CGS04 - DC Mixer

Size A4	FCSM No. 28/05/2006	DWG No. CGS04.sch	Rev 1
Scale	Laurie Biddulph	Sheet 1 of 1

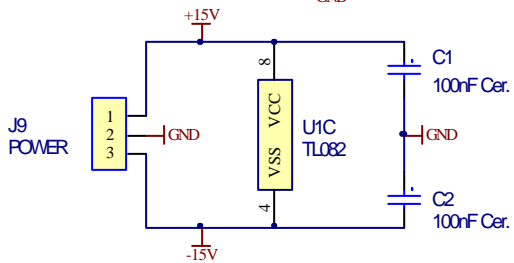
Corrections to Ken's website:
C1 and C2 are 100nF Monolithic Ceramics/Polyester not Electrolytics.
R10 and R11 are supplied as 1K not 3K3
